File Number
PDC03-098

Application Type
Planned Development Rezoning

STAFF REPORT

Proposed Use: Up to 105 single-family detached residential units

44' Public Right of Way (North Neighborhood)

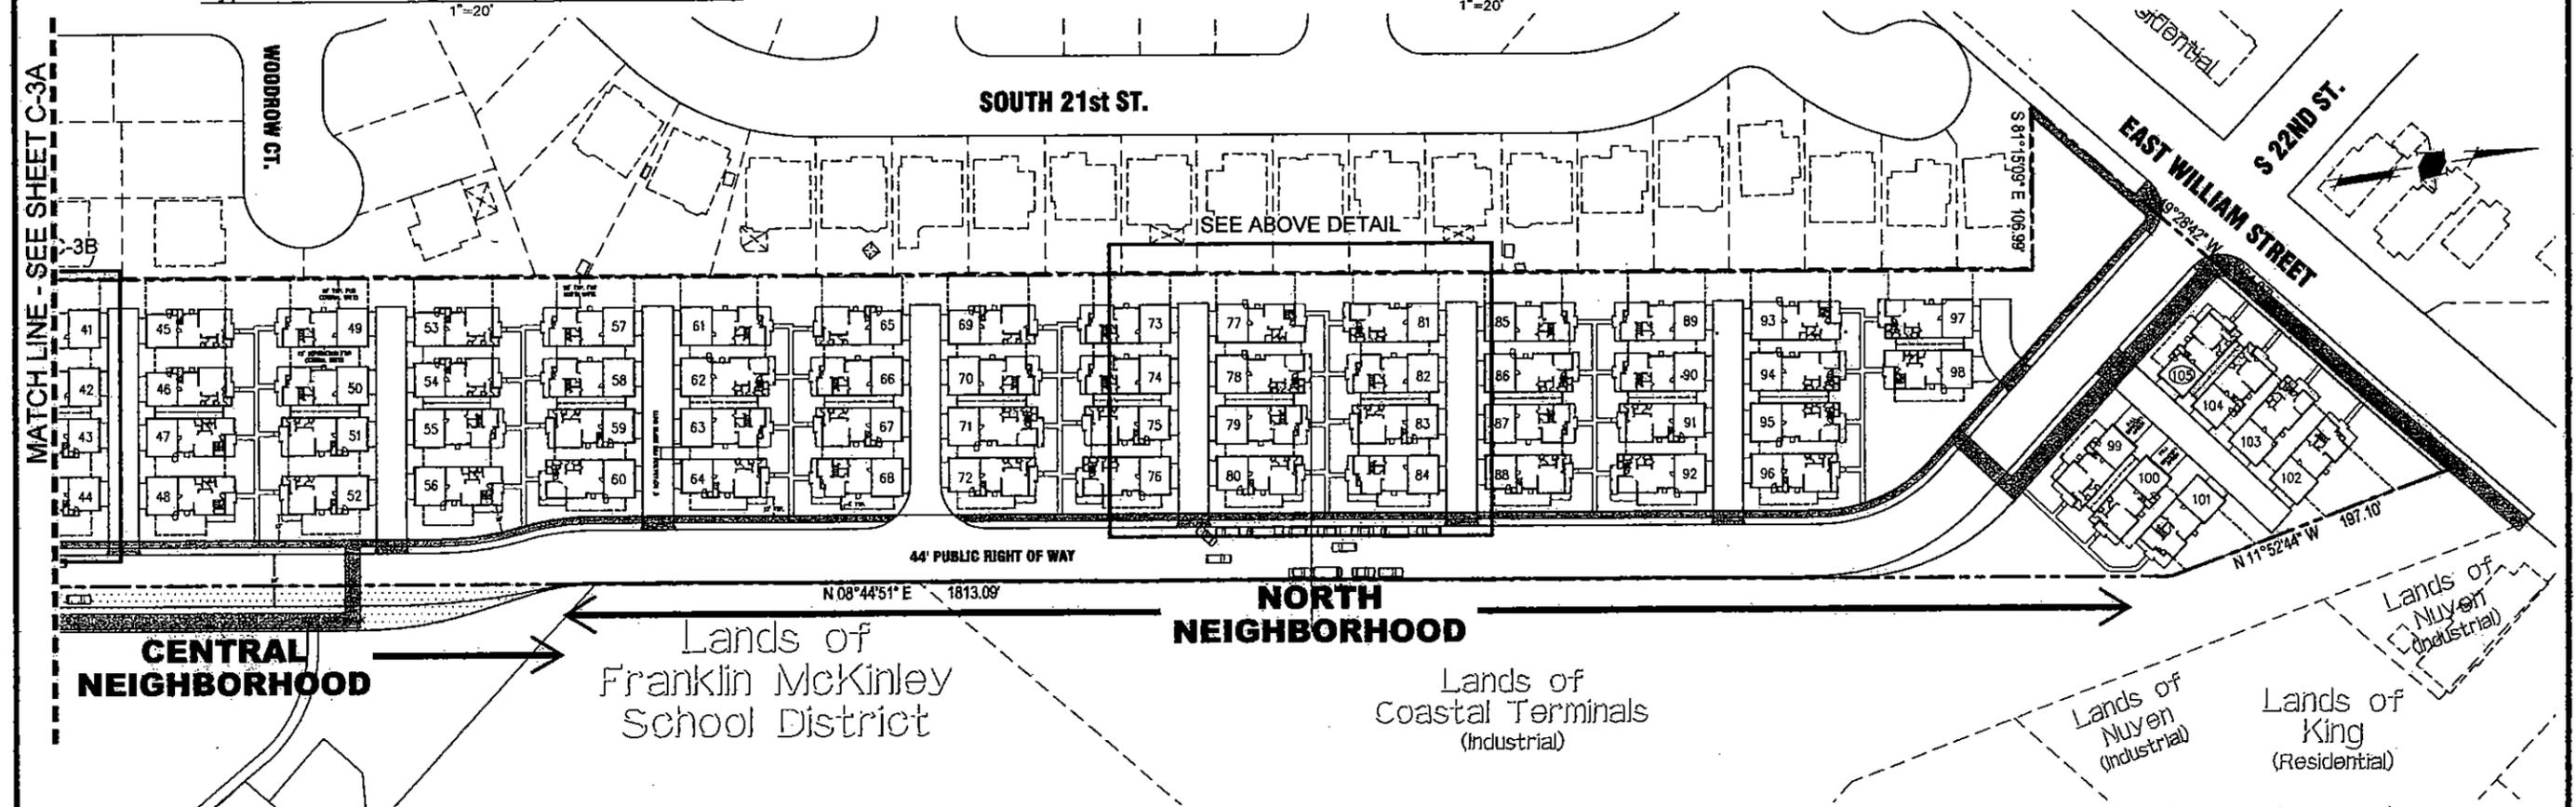
- A. Roads and/or driveways shall have a minimum clear width of 20 feet. Uniform Fire Code, Section 902.2.2. All details for public right of way show only 18 feet clearance.
